Optimize FOM Reduction

COM Commit Request Number 4p8_6

Adam Gregory, Samtec

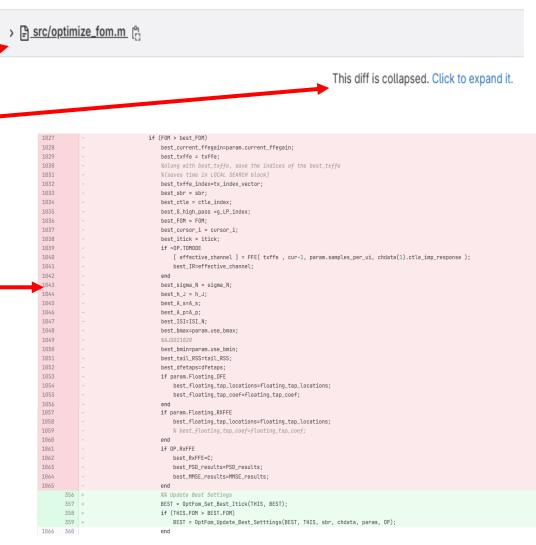
- This URL shows the diffs in optimize_fom:
 - <u>Compare main vs. Reduce Optimize FOM</u>
 - Scroll to the bottom to see "src/optimize_fom.m"
 - It will say "This diff is collapsed. Click to expand it"
 - Click that to see all the diffs
- In general, the diffs look as shown on the image to the right
 - A bunch of lines pushed into subfunctions
- Due to the nature of this refactoring, it is difficult to visually observe the changes.
